**FEDERAL COMMUNICATIONS COMMISSION**

In re: K220HC, Sun Valley, CA  
BPFT-20100526ACY  
Facility ID # 91759

This refers to: (1) the above-captioned application for K220HC, Sun Valley, California.

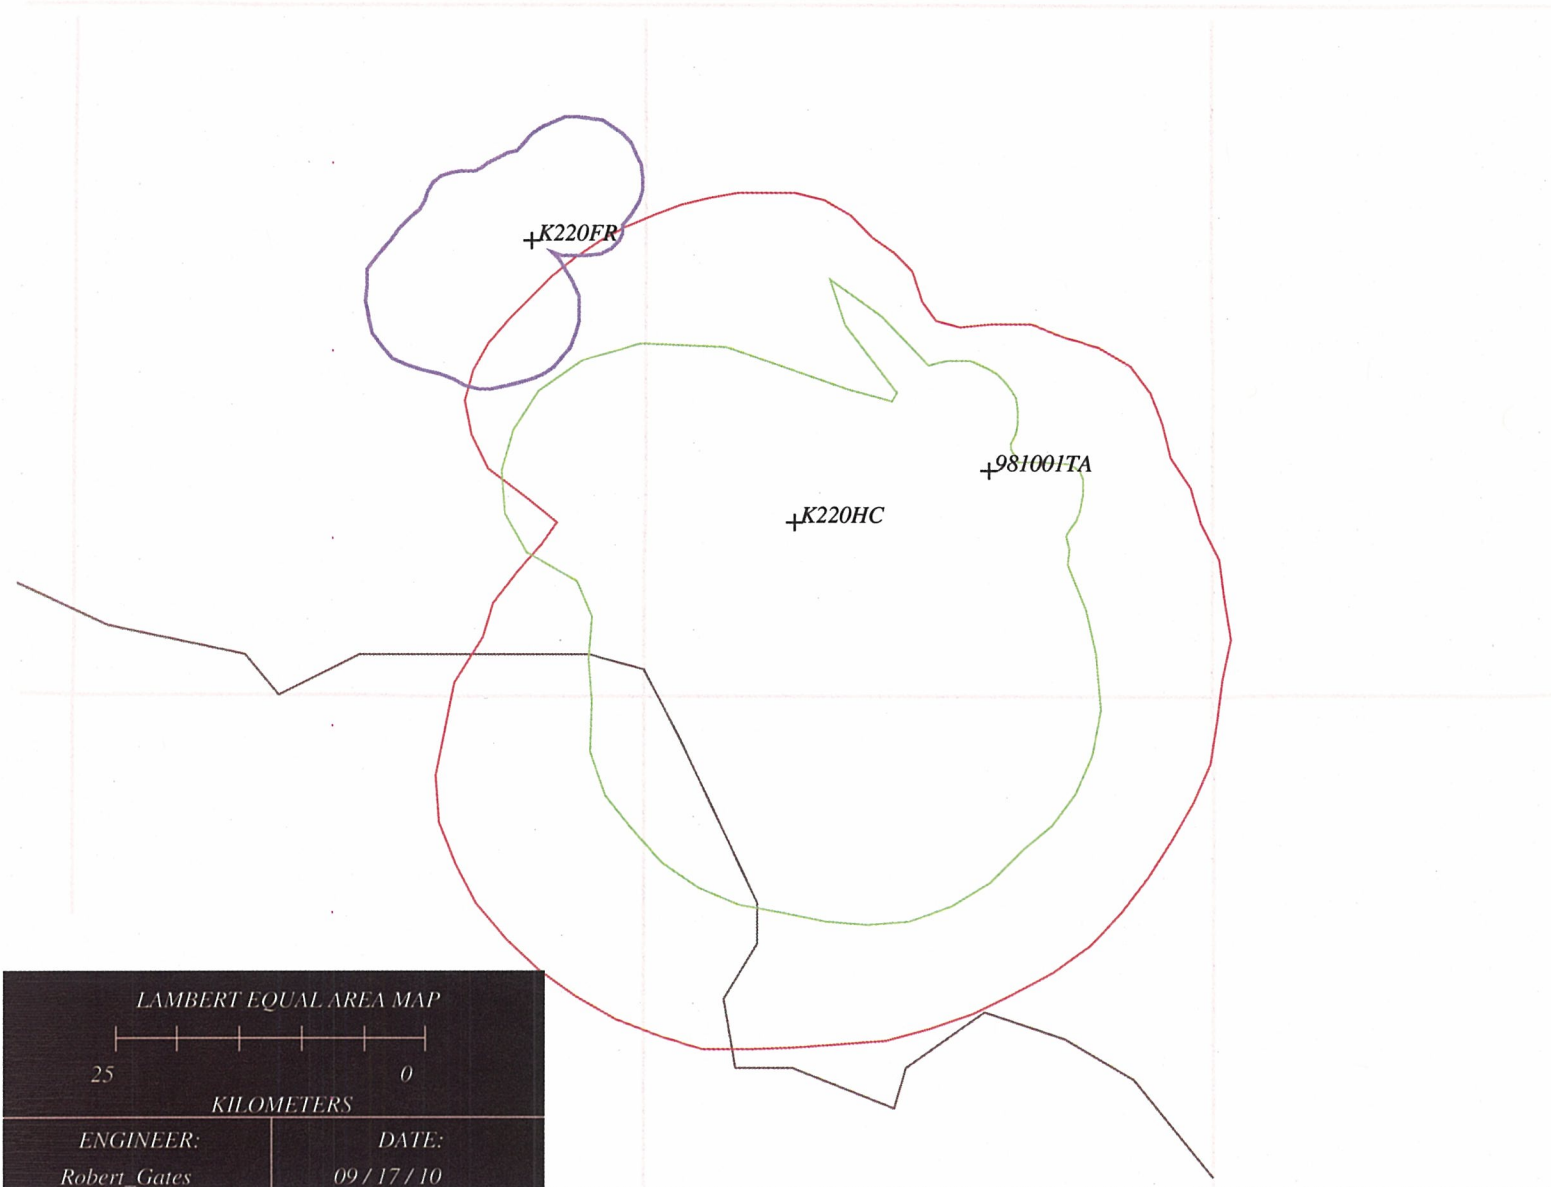
An engineering study has revealed the application violates 47 C.F.R. § 74.1204(a) with respect to K220FR, Simi Valley, California (BLFT-20061221AAO). Section 74.1204(a) states that an application for a FM translator station will not be accepted if the proposed operation would involve prohibited overlap of predicted field strength contours with any other authorized station. The proposed 40 dBu interference contour overlaps with the 60 dBu protected contour of K220FR. The applicant acknowledges the prohibited overlap and requests a waiver stating there is terrain shielding therefore no interference is possible. No additional supporting documentation was supplied. The applicant has not demonstrated that this waiver is unique and compelling. When an applicant seeks waiver of the rules, it must plead with particularity the facts and circumstances which warrant such action. *Columbia Communications Corp. v. FCC*, 832 F.2d 139, 192 (D.C. Cir. 1987), quoting *Rio Grande Family Radio Fellowship, Inc. v. FCC*, 406 F. 2d 644, 666 (D.C. Cir 1968 (per curiam)). We have afforded Living Way Ministries, Inc.'s waiver request the "hard look" called for under *WAIT Radio v. FCC*, 418 F. 2d 1153 (D.C. Cir. 1969), but find that the facts and circumstances presented are not sufficient to warrant waiver of 47 CFR Section 74.1204.

Accordingly, the request for waiver of 74.1204(a), IS HEREBY DENIED, and the Application BPFT-20100526ACY IS HEREBY DISMISSED. This action is taken pursuant to 47 C.F.R. § 0.283.
